# Providence City Plan Commission

## AGENDA ITEM 3 ■ 153 CARPENTER STREET

**CASE NO./ PROJECT TYPE:** 20-040 UDR—Unified Development Review

Minor subdivision with special use permit and dimensional variances

PRELIMINARY  
 MADOFF PLAT

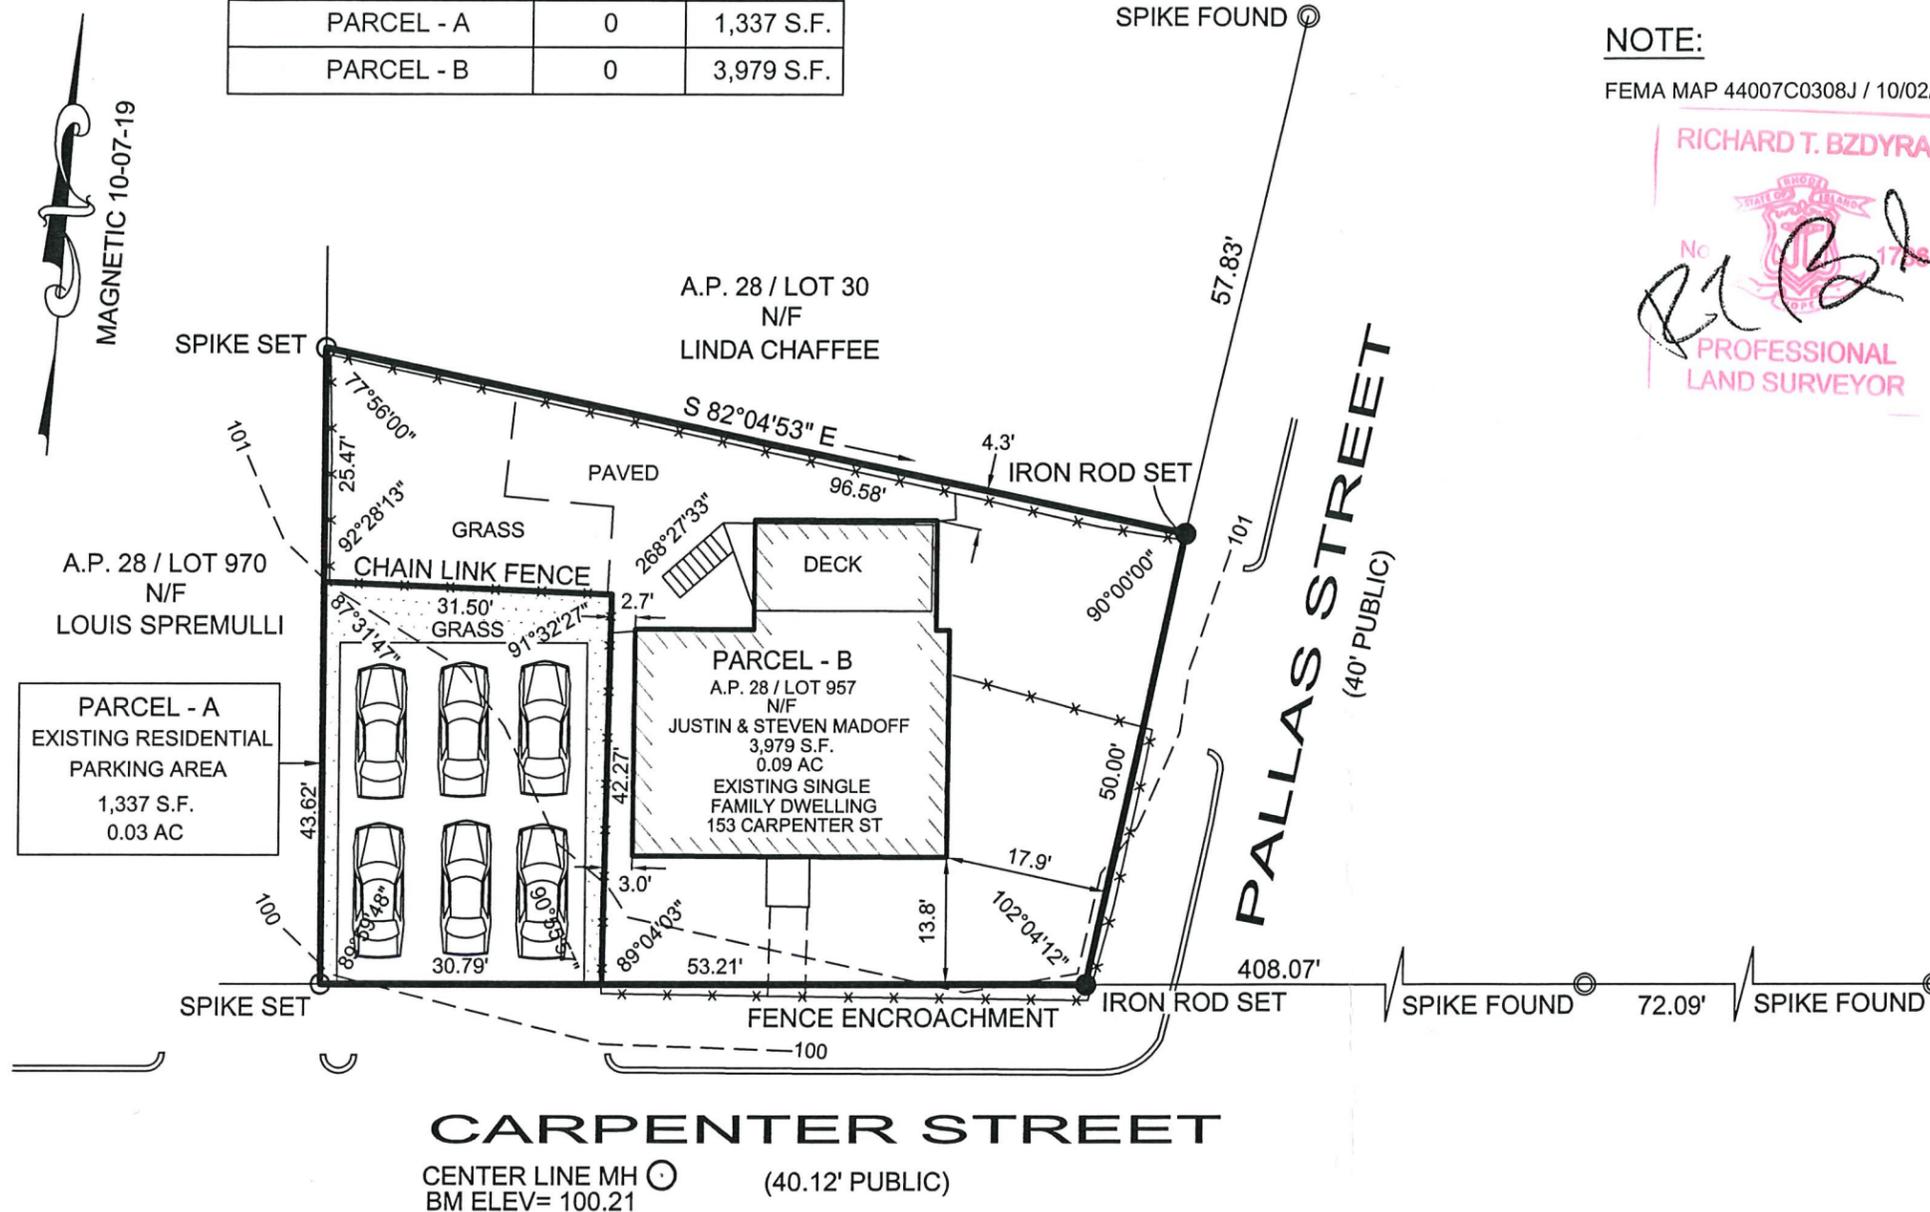
The subject property is occupied by a single family dwelling and measures approximately 5,316 SF. The applicant is proposing to subdivide the lot into two lots of 3,979 SF and 1,337 SF with widths of 53.21' and 30.79' respectively. The single family dwelling will remain on the larger lot, and a six space parking lot is proposed for the smaller lot, which requires a special use permit. The minimum required lot size for new subdivisions in the R-3 zone is 5,000 SF with a width of 50 feet. Pursuant to Unified Development Review (UDR), the applicant is seeking dimensional variances from provisions related to minimum lot area and minimum lot width. Relief from the side and rear yard setback requirements are also requested based on the proposed lot line. A rear yard setback of 10' is required but approximately 5' will be provided. A side yard setback requirement of at least 6' is required but approximately 3' will be provided. In addition, the applicant is seeking relief from the total maximum impervious surface coverage, landscaping for parking lots, canopy coverage requirement and maximum driveway width.

Based on plans provided, it appears that the requested relief is necessary due to the unique characteristics of the subject property. The applicant has submitted a use card from the Department of Inspection and Standards indicating that the legal use of the site has been a parking lot since 1957. The single family dwelling was built in 1972, after the use of the parking lot was established. It is conceivable that the presence of the parking lot affects the use and enjoyment of the dwelling, resulting in a hardship. The subdivision would allow use of the parking lot to continue, and exist separately from the residence. The area available to situate the existing dwelling on a separate lot requires placement of the lot line in a location that triggers the need for relief. Based on the lot's configuration, it is not possible to subdivide the property without relief from impervious surface coverage, setback, and landscaping requirements due to the size and layout of the property. The lot's dimensions will not allow for installation of a planting strip required for parking lots or the appropriate amount of canopy coverage. The need for relief is related to the size and dimensions of the lot, as well as use of the property, which collectively contribute to the applicant's hardship.

The use of the parking lot has existed since 1957. The nature of the parking lot and the dwelling is not expected to change upon subdivision. An effect on the character of the surrounding area is not expected as the use on each lot will remain the same. It is the DPD's opinion that the applicant can take some steps to enhance the character of the surrounding area. As landscaping on the lots is not possible, the applicant should make an equivalent amount of offsite plantings under the supervision of the City Forester which would improve the

Based on the foregoing discussion, the DPD recommends that the CPC approve the variances from the minimum lot size, minimum lot width, rear and side yard setback requirements, maximum impervious surface coverage, canopy coverage and landscaping, finding that they can be supported based on the criteria for granting a variance. The relief should be granted subject to the following condition:

The applicant shall make offsite plantings, equivalent to the amount of required site landscaping, under the supervision of the City Forester.

The applicant shall file a lien on the spaces in the parking lot for use by the building at 135 Carpenter Street.

Based on the analysis and findings contained in this report, the CPC should approve the subdivision subject to granting the requested relief. The CPC should grant preliminary plan approval subject to the following conditions:

1. Final plan approval should be delegated to DPD staff.
2. The validity of the approval shall be extended to one year from the date of recording of the approval letter.
